ADDENDUM NO. 1

DATE: 05-21-2025

RE: Colton Joint **Unified School District**  
**Bid No. 25-020FAC 900 E. Washington Seismic Retrofit and Roofing Project - Rebid**

**FROM:** MILLER ARCHITECTURAL CORPORATION  
1177 Idaho St, Ste 200 Phone: 909-335-7400  
Redlands, CA 92374 Fax: 909-335-7299

EXHIBIT 'A'

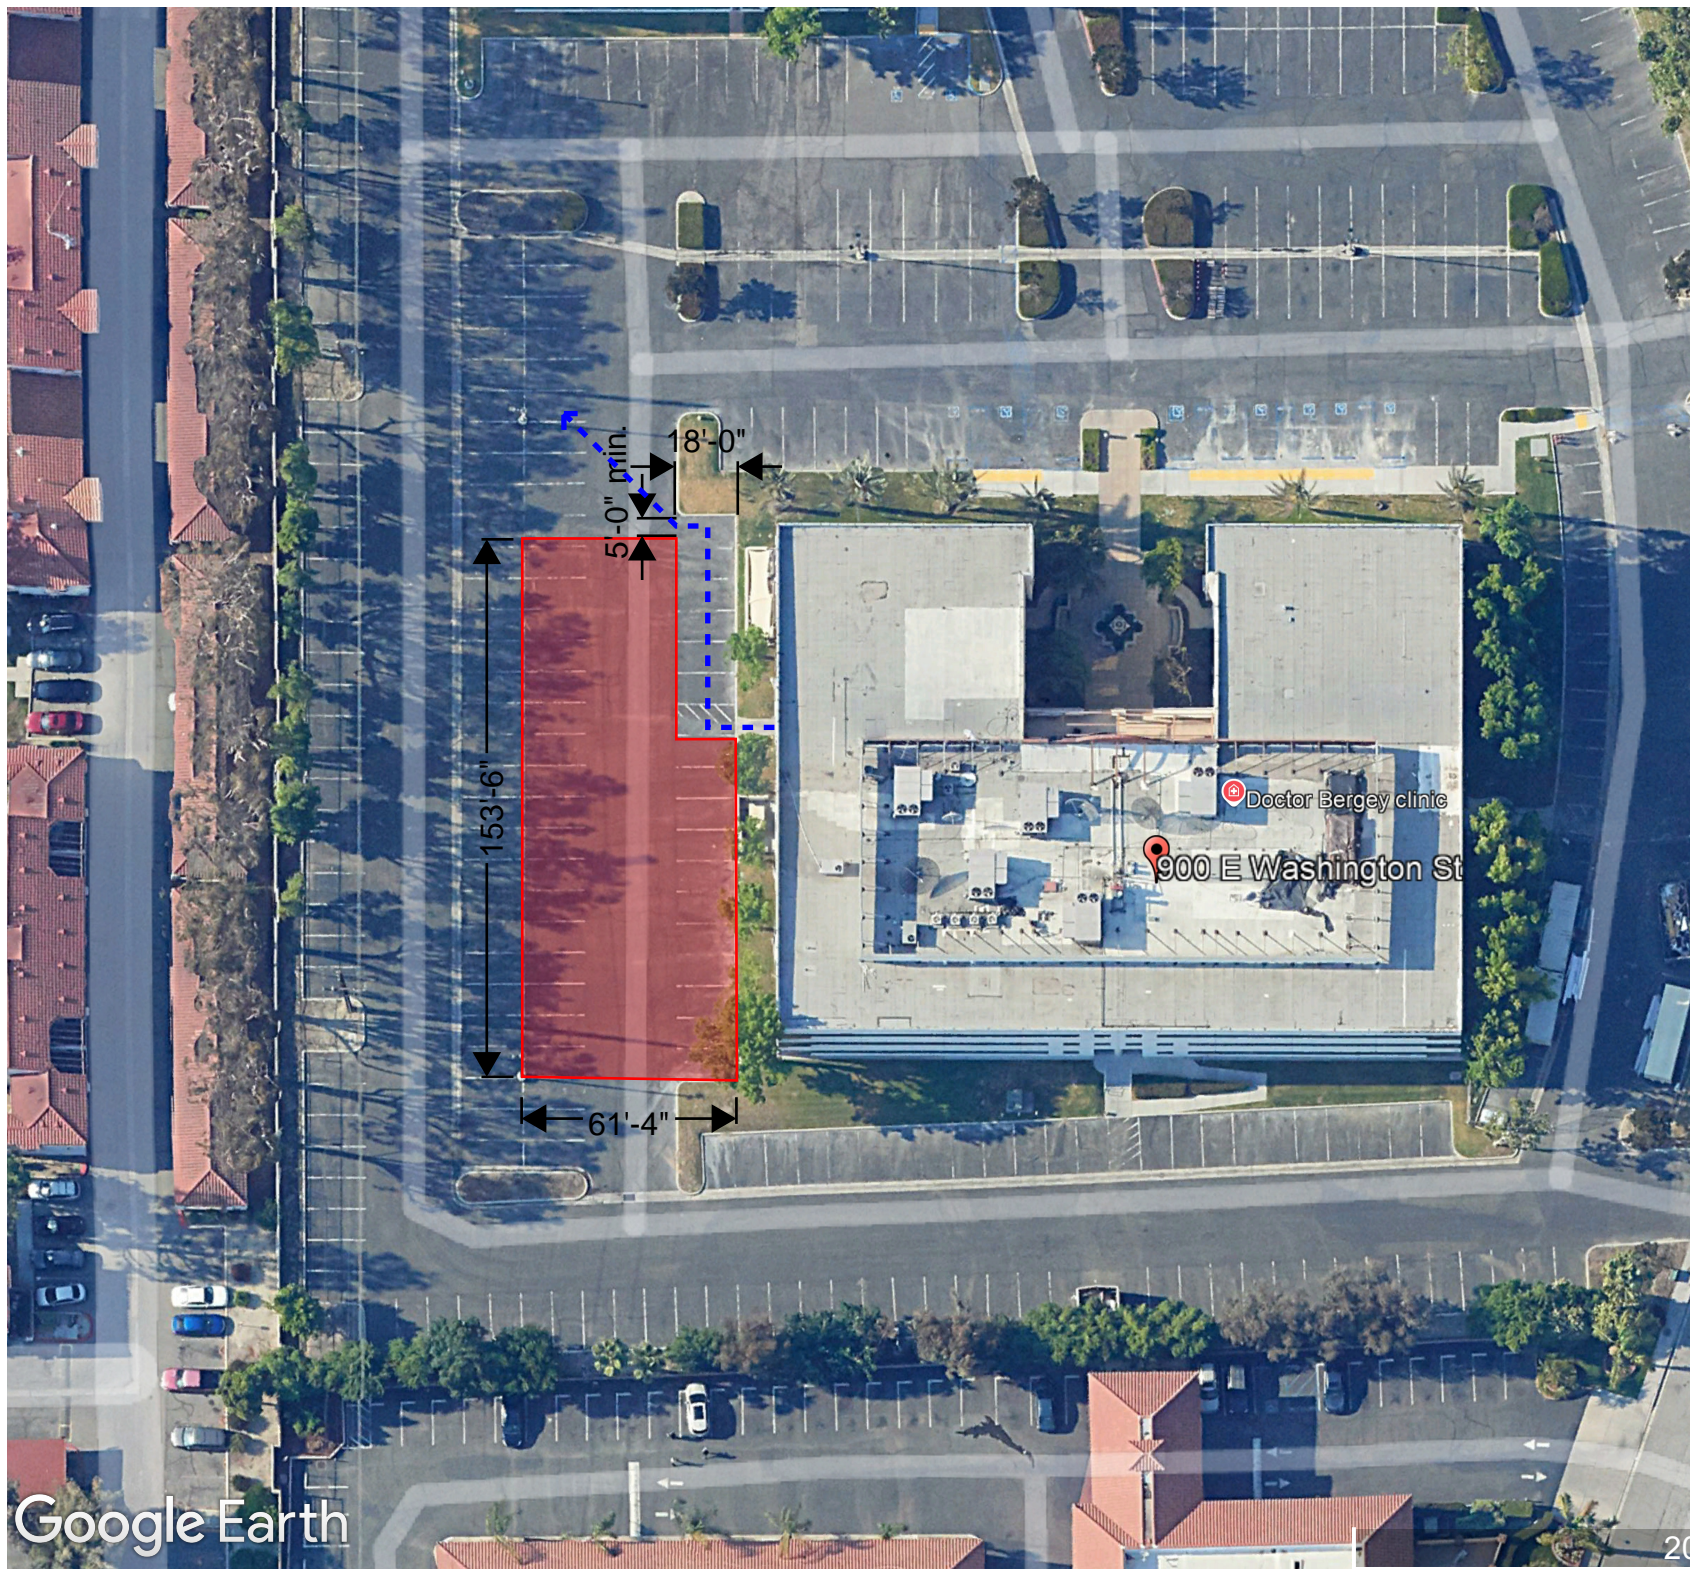
- Item I-3.** Refer to Exhibit A for staging and laydown area. Signage to be provided by contractor for emergency exiting and emergency plan. Contractor is responsible for safety. Exit at west of building shall only be used as an emergency exit during construction and the district shall be responsible for informing employees and users of this information.

- Item I-5.** A diagrammatical lay down plan (Exhibit A) has been provided as an attachment to Bid Addendum 1. Dimensions are approximate and should be verified in field by contractor. A cover over the emergency exit path shall not be required, however, all work shall stop immediately in the event of an emergency. The new layout is designed such that the emergency exit path shall never be obstructed by equipment or materials.

ALL DIMENSIONS  
ARE APPROXIMATE,  
PLAN IS  
DIAGRAMATIC.

UNISTRUT &  
RUBBER FEET  
(VIBRATION  
ISOLATION  
BLOCKS)

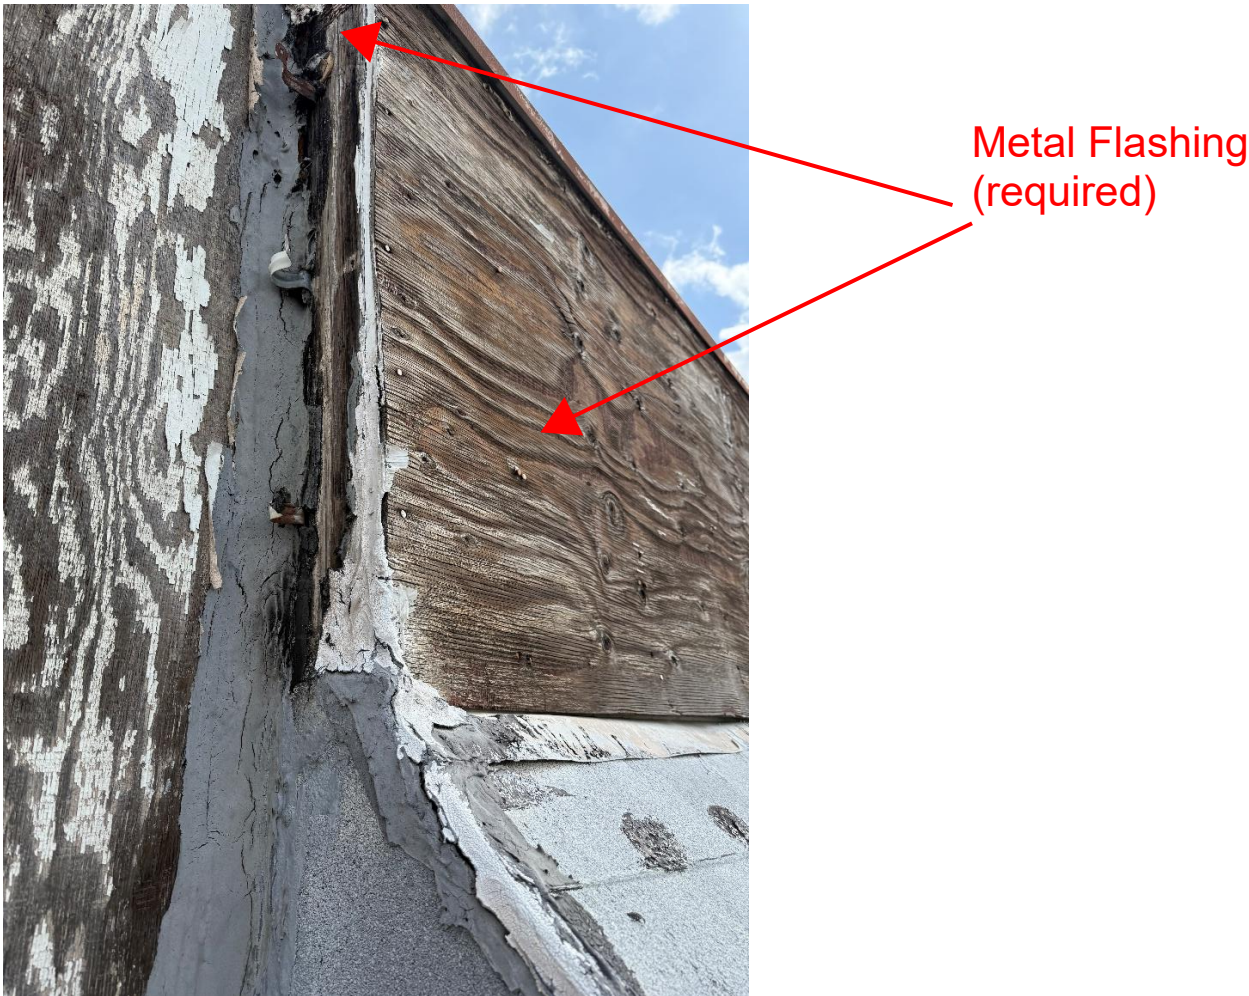
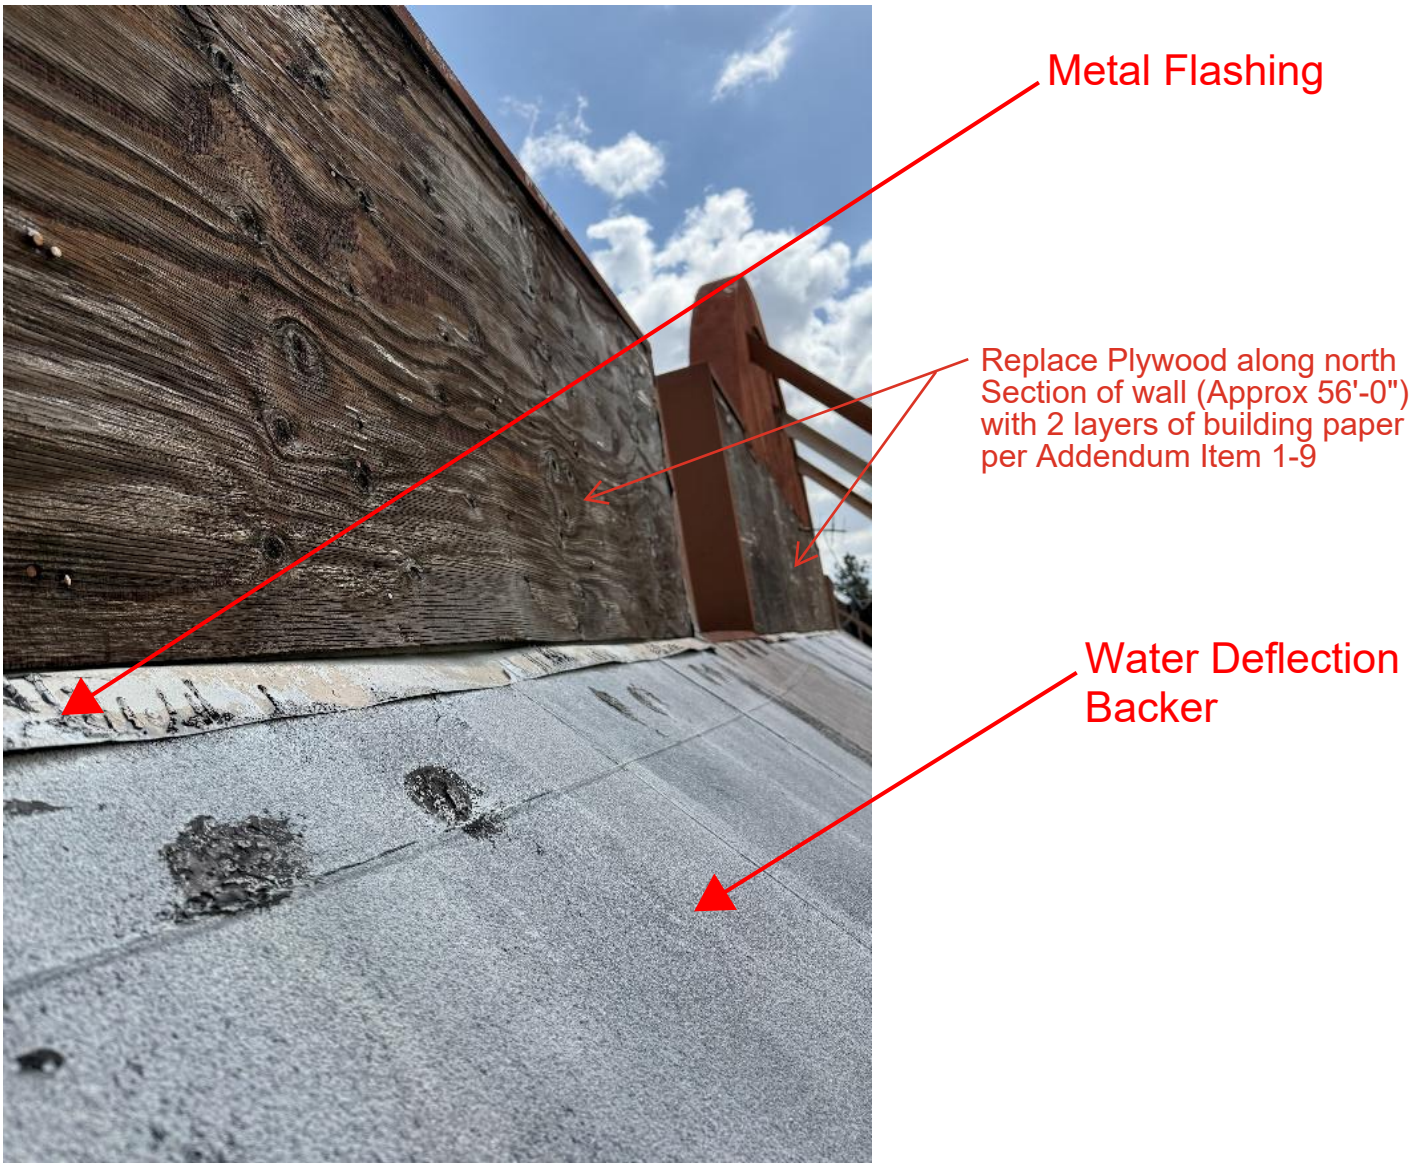
**Scope Clarification 002: Mechanical Equipment (removed & replaced)** - for all mechanical equipment temporarily removed in order to install the new roof system, it must be reset on the roof using a Unistrut support system with rubber feet (e.g. vibration isolation blocks (made of neoprene or recycled rubber)).

- Unistrut support systems with rubber feet
- Vibration isolation blocks (made of neoprene or recycled rubber)
